ADDENDUM 01, DELTA 01

DATE 01.30.2026

PROJECT: Santa Rosa Freestanding Emergency Room

ARCHITECT'S PROJECT NUMBER:
225014.00

G101

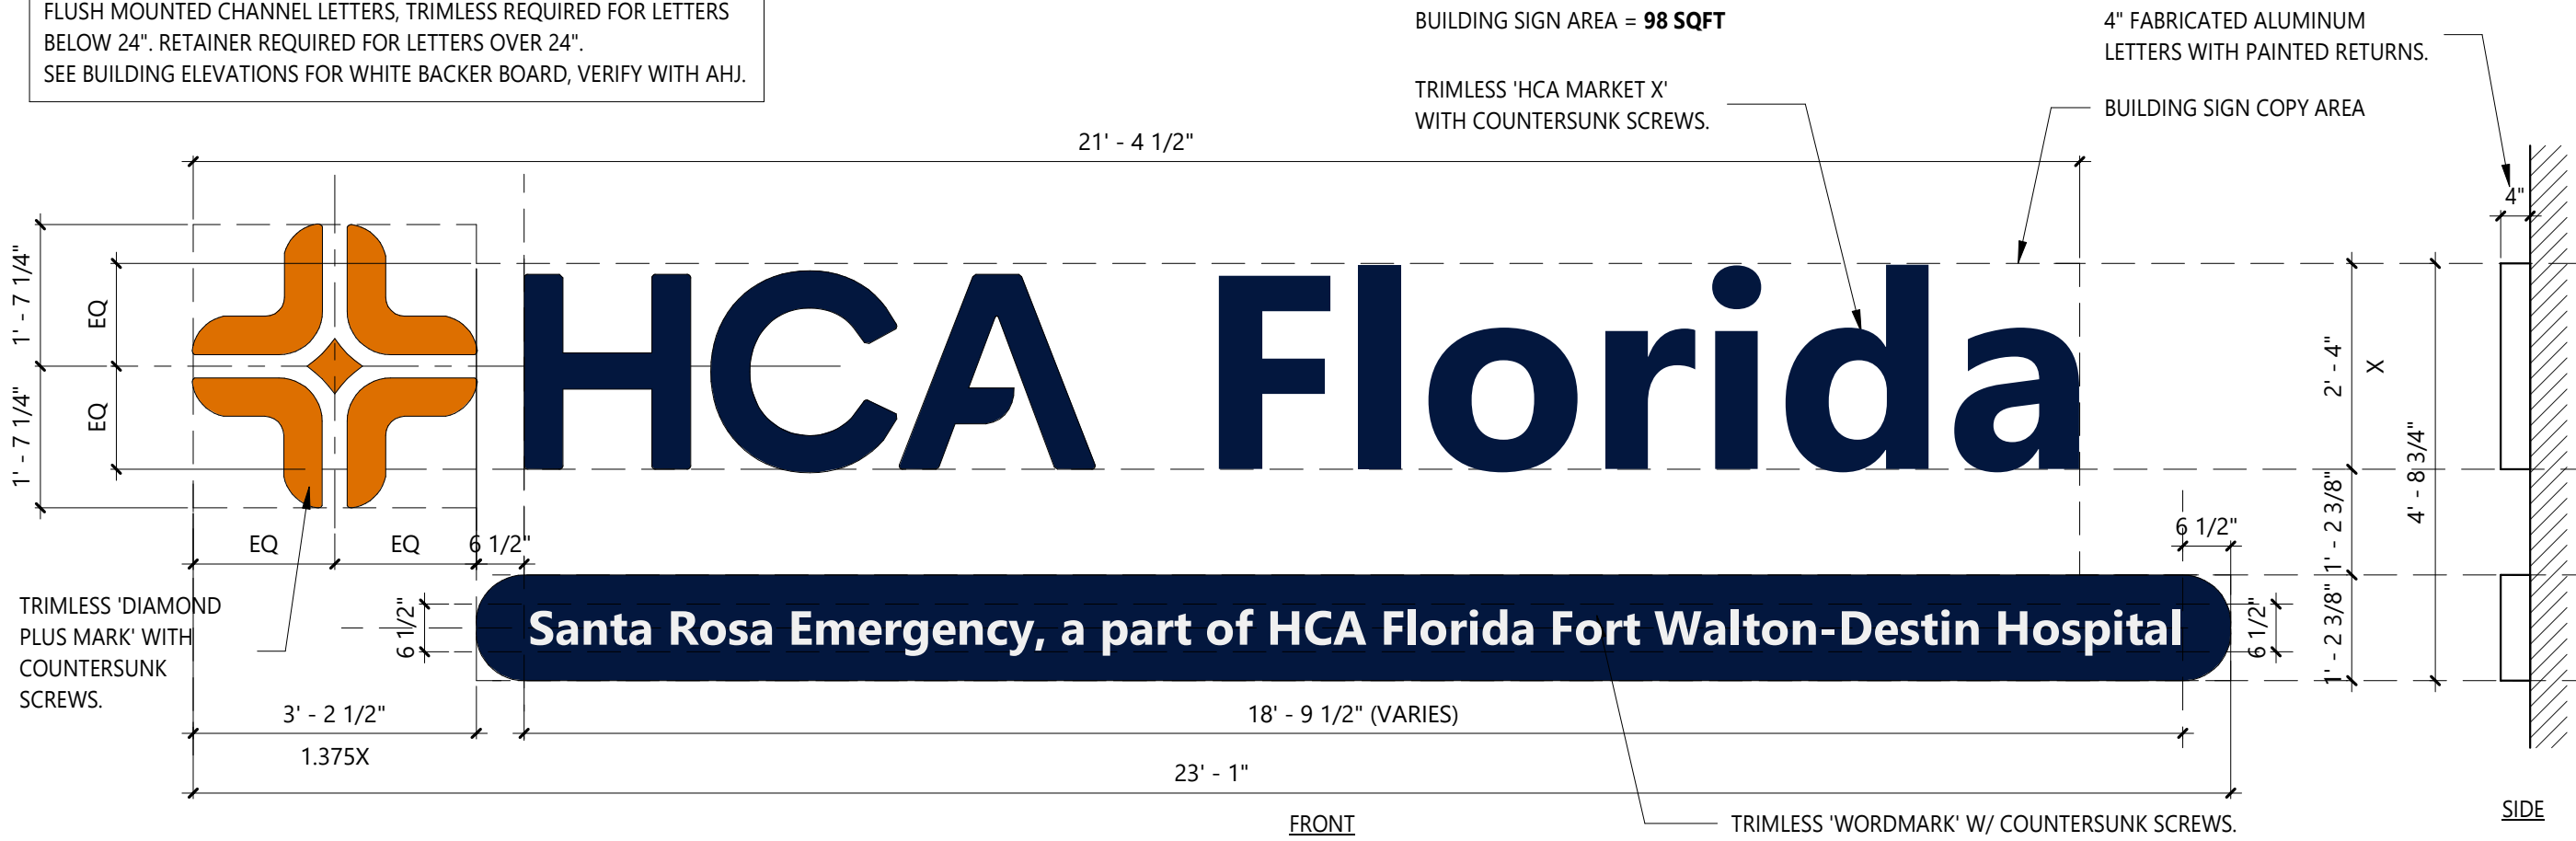
1. Reference "Partition Fire Rating Legend:"
 - a. Revised the definition of the smoke barrier to read: "Smoke Barrier (1-HR)" for additional clarification.
2. Reference Detail 1: "Floor Plan – Life Safety:"
 - a. Room tag added to indicate the location of the linen alcove per AHCA Stage II review comment.

1 SITE ORIENTATION PLAN
SCALE: 3/64" = 1'-0"

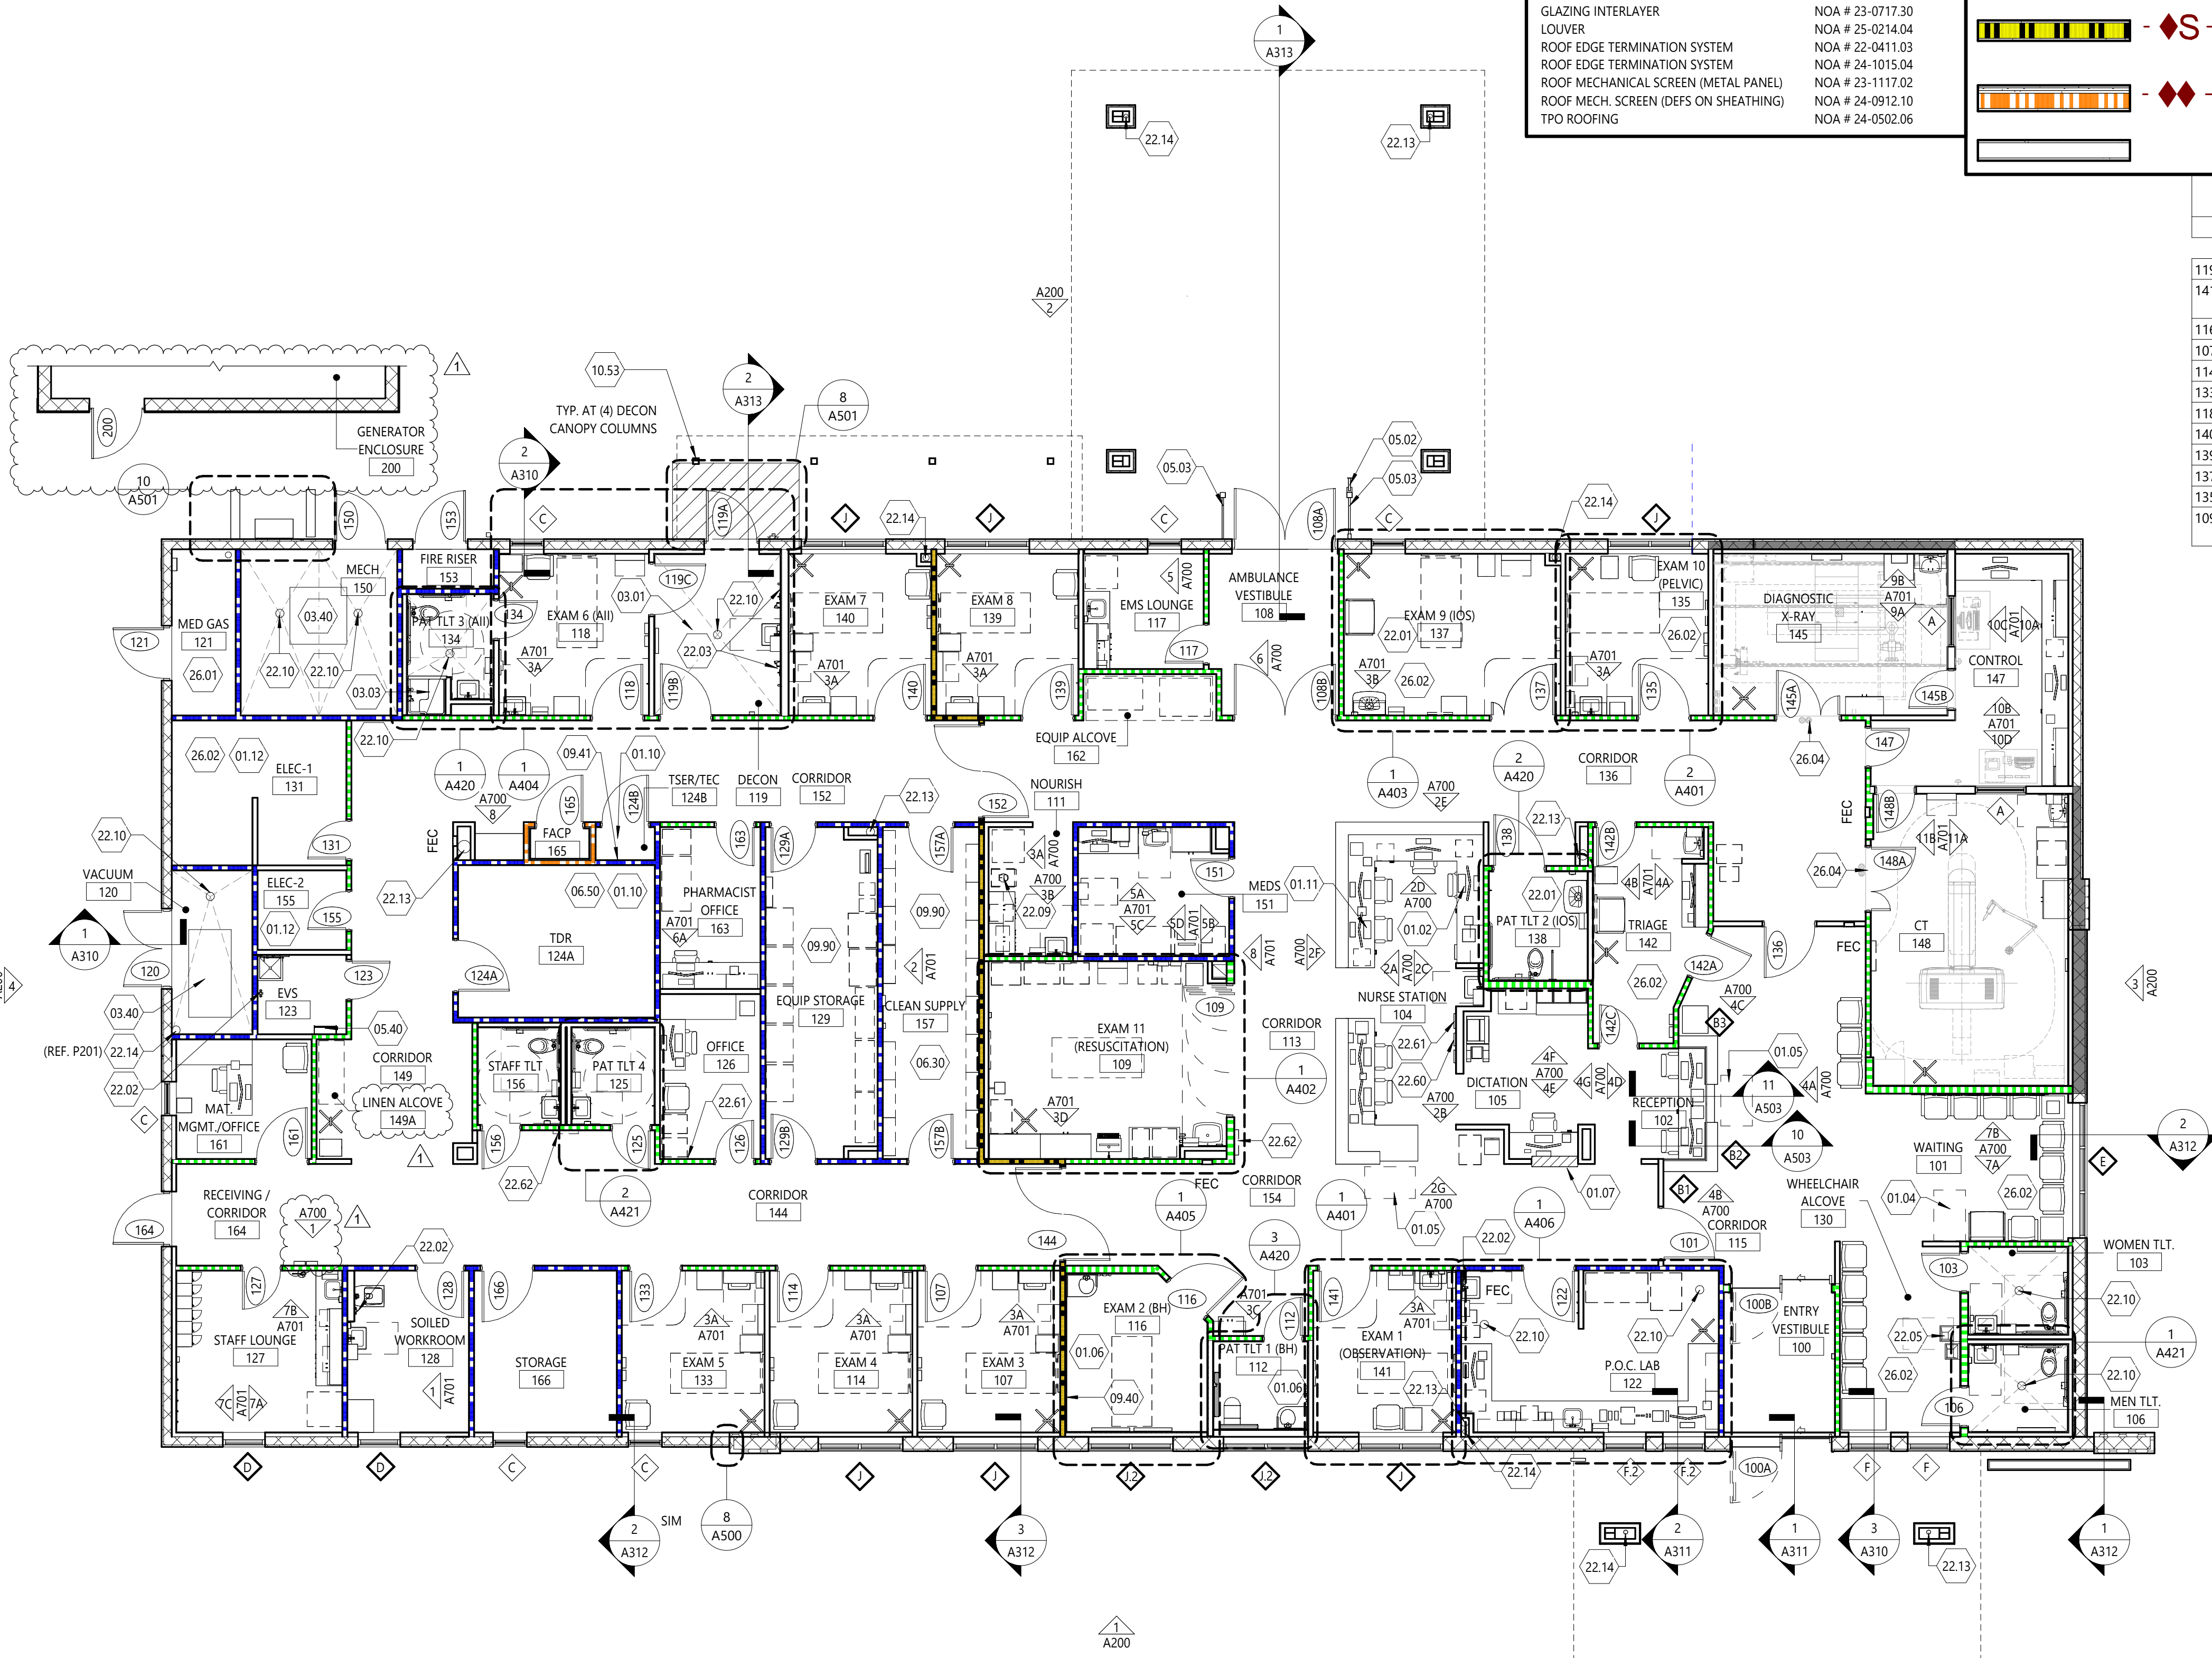
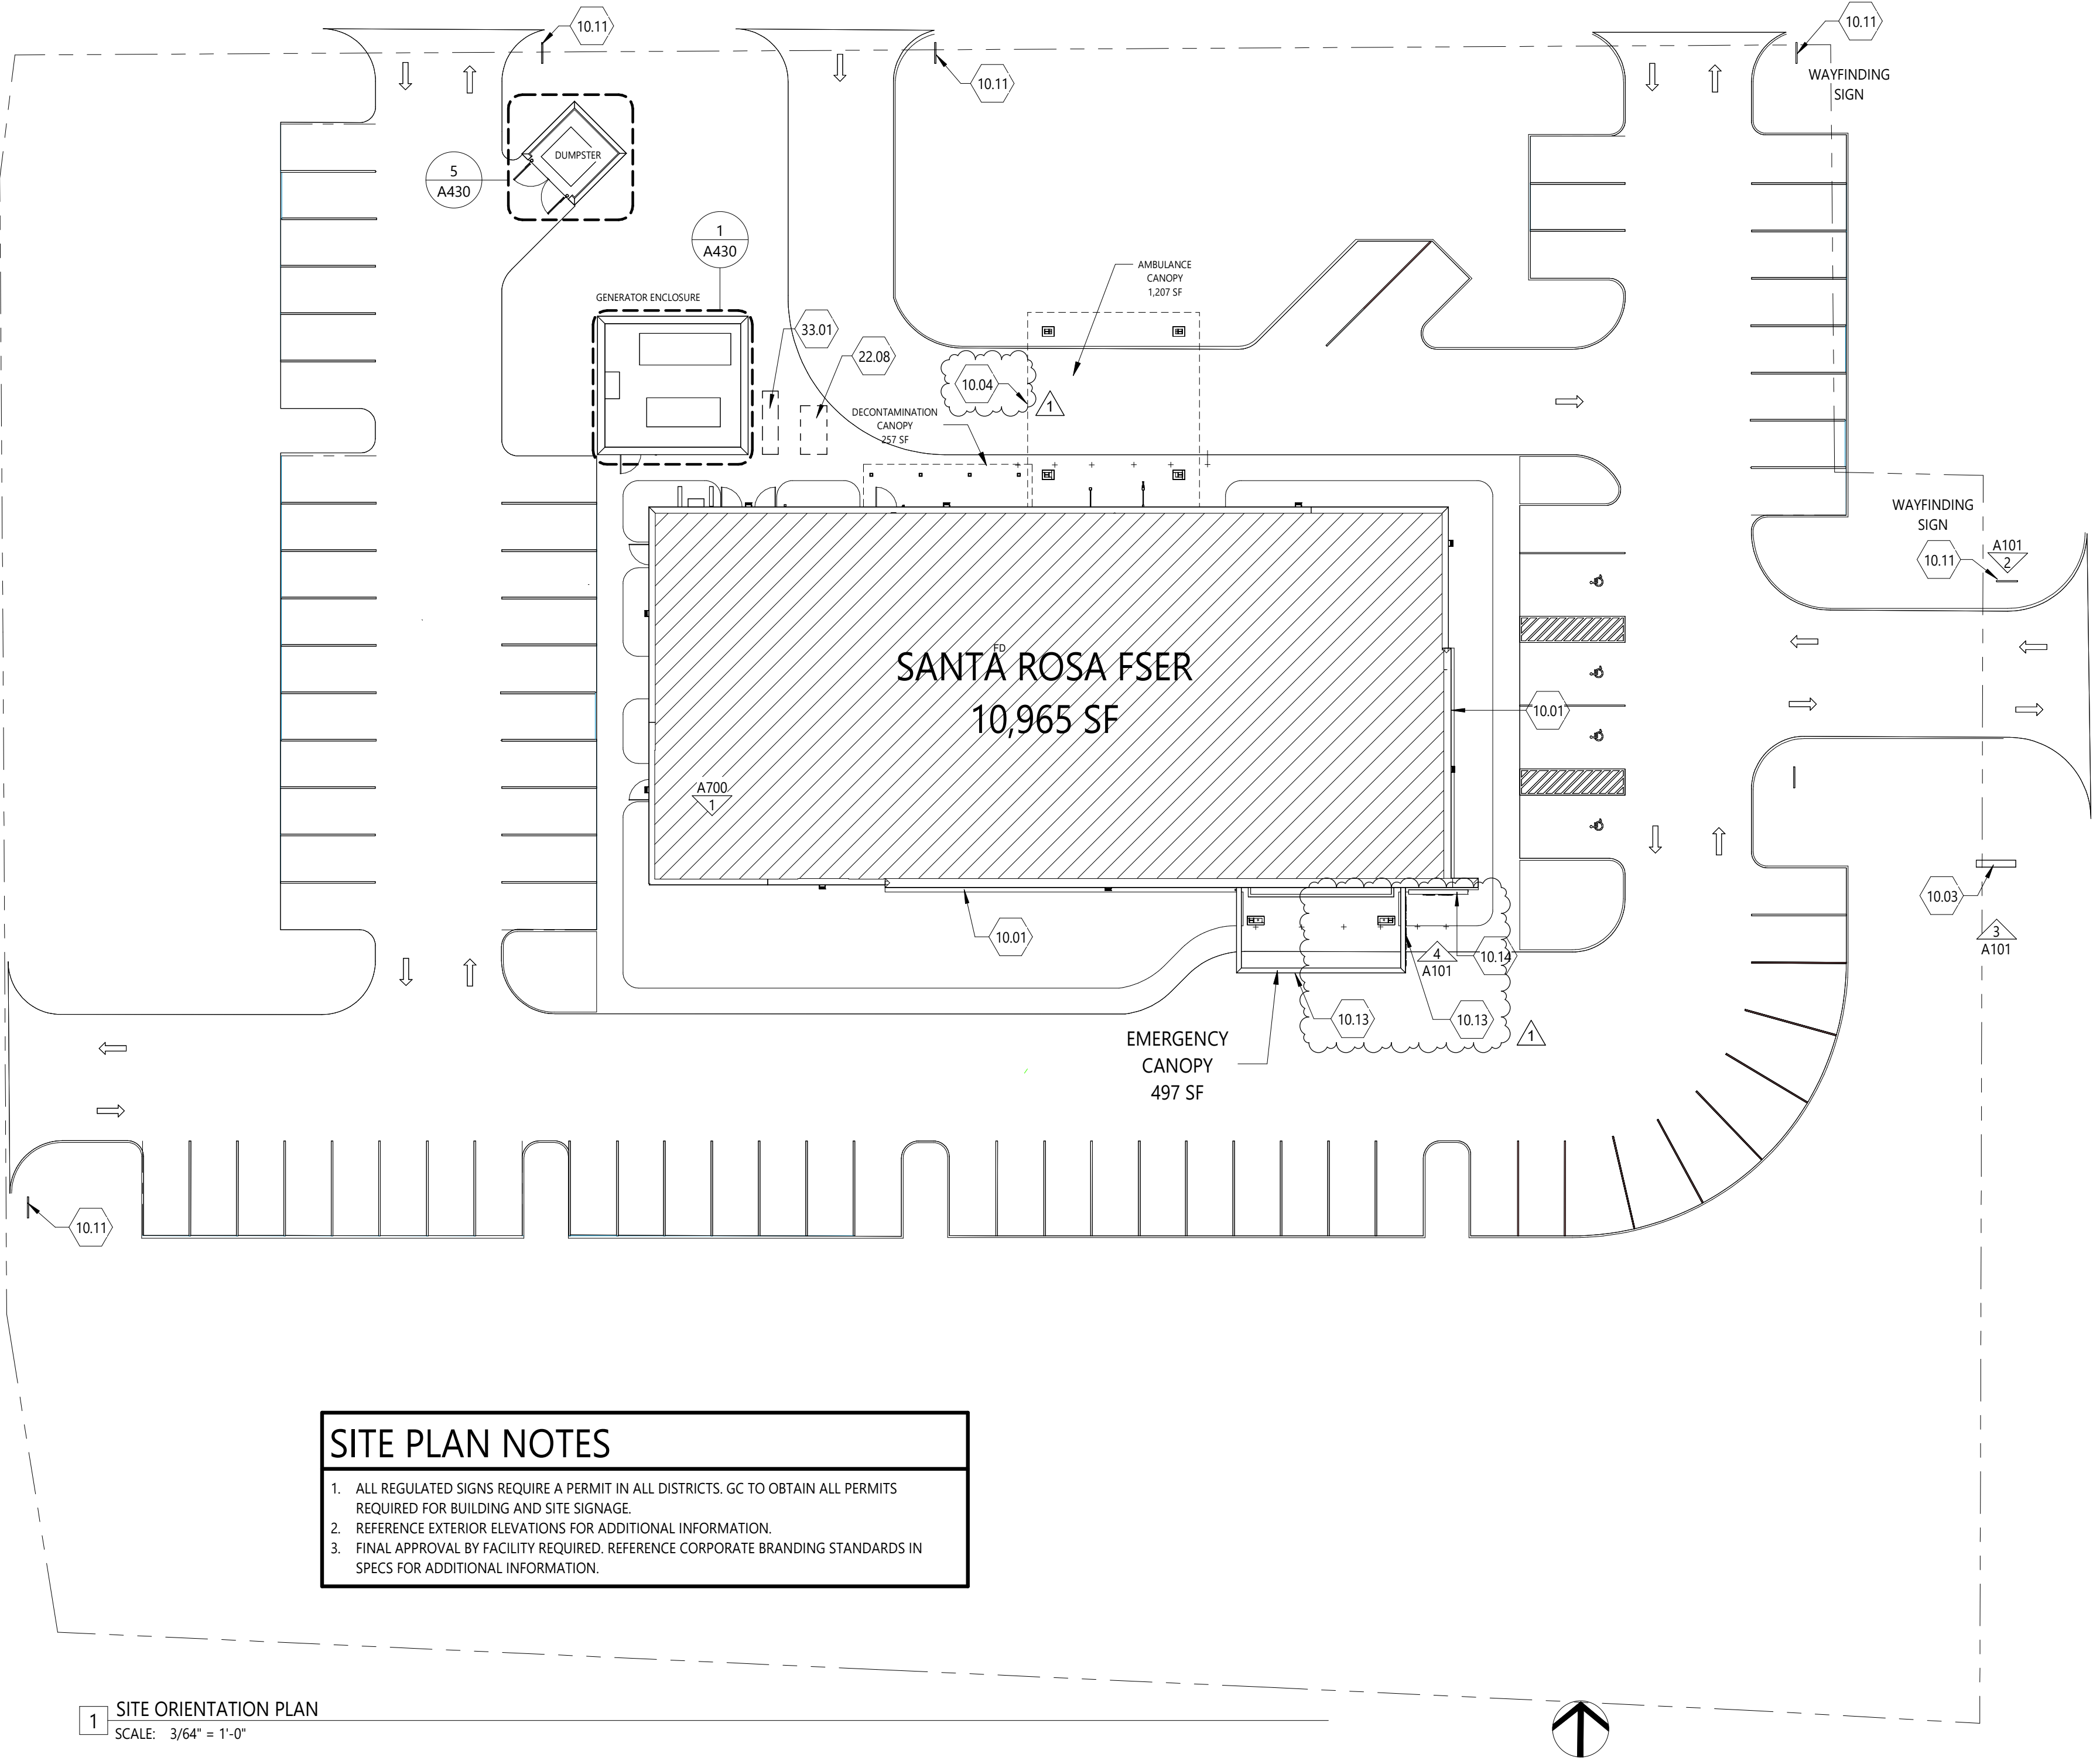
1. Reference "Keynote Schedule:"
 - a. Added keynote 10.04 regarding the ambulance sign for additional clarification.
2. Reference Detail 1: "Site Orientation Plan:"
 - a. Added keynote 10.04 regarding the ambulance sign for additional clarification.
 - b. Removed one of the references to keynote 10.13 regarding the emergency sign above the sliding entrance doors. Sign has been removed from project scope.
3. Removed Detail 5: "Emergency Sign (Above Sliding Emergency Door)"; sign has been removed from project scope.
